Project Name	Plot H3, AccorTribe Hotel, Manchester
Project Number	1513
Document	Drainage Technical Note
Date	13 th September 2024
Revision	V1
Prepared By	SK

From: Darren Lewis <Darren.Lewis@manairport.co.uk>
Sent: 27 July 2021 10:02
To: Watton, Joseph
Cc: Rumsey, Chris (Chris.Rumsey@fgould.com); Bamford, Vin; Mike Curry
Subject: [EXTERNAL] RE: H3 Hotel (Central Business District) - Proposed Discharge Rates

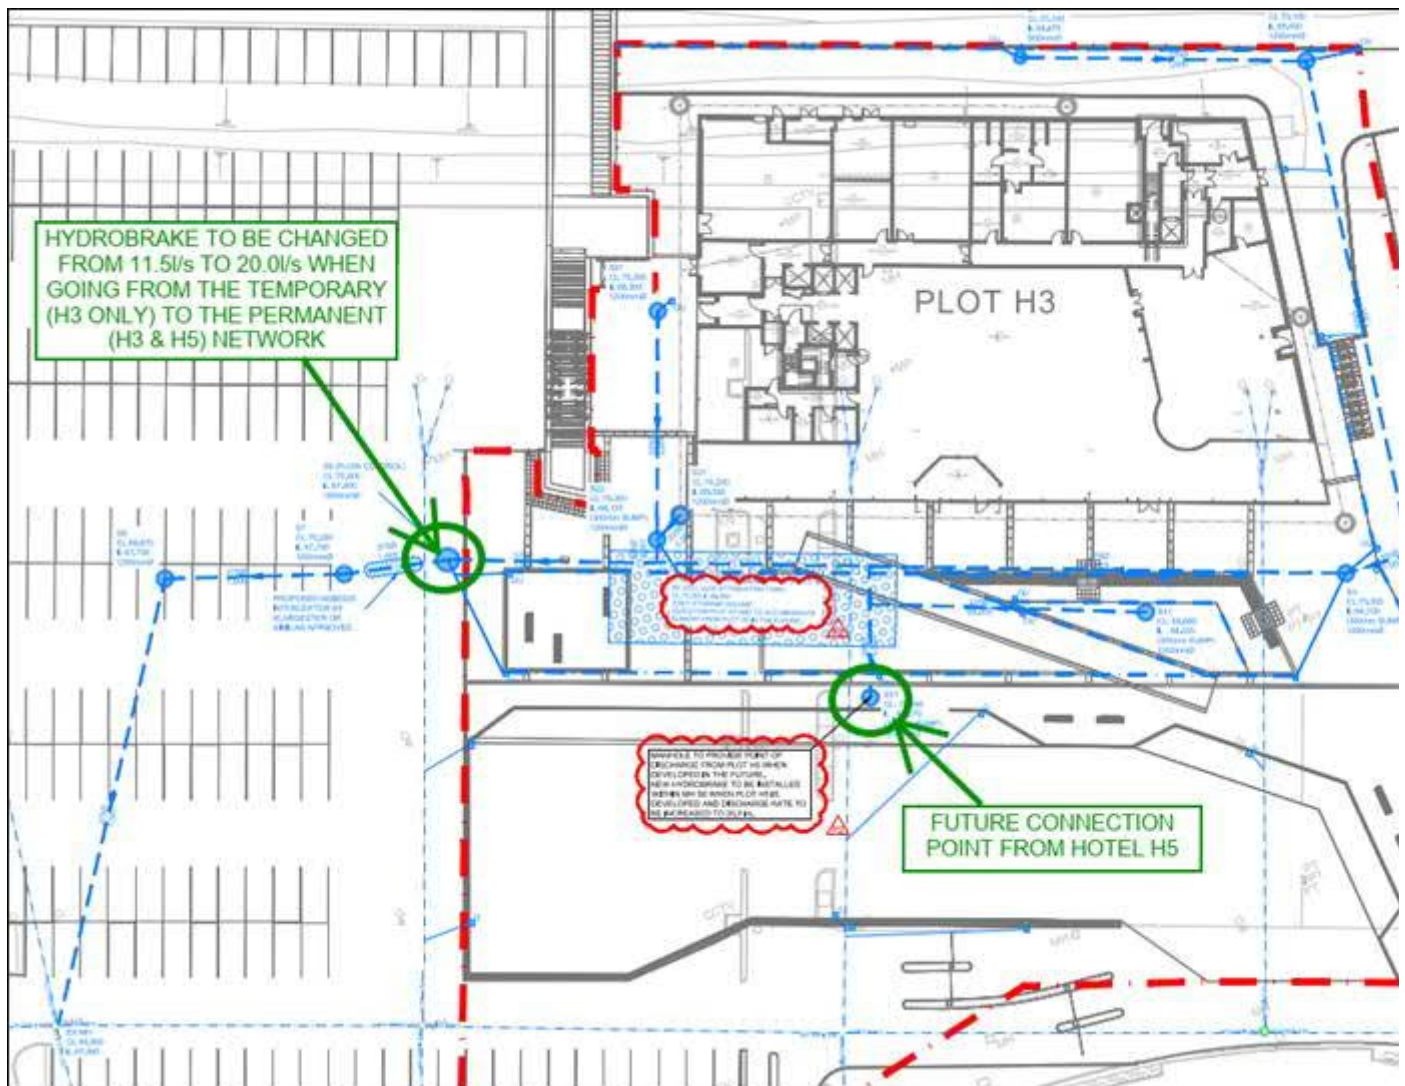
The reason we have a temporary and a permanent network is because the attenuation tank we have proposed will be in place to facilitate the future run-off from Hotel H5. H5 will not be in place for a period of time so prior to this we have a temporary network (H3 Hotel only) with a Hydrobrake that will need to be replaced on completion of the H5 hotel to increase the discharge rate from 11.5 l/s to 20 l/s.

You will note that these discharge rates are lower than any of those listed in Table 2 above. This is to ensure that we do not exceed the equivalent run-off volume for a 1 in 100-yr 6 hour event when compared to the existing site as this is another MCC condition we need to satisfy. Below is an annotated screenshot of the network that may assist to explain the text above.

I have reviewed the proposals below and can confirm I'm happy for you to proceed on this design basis.

Please be advised MAG must be consulted on any variations to the mentioned design.
Surface Water Management Plans to be considered for subsequent design stages.
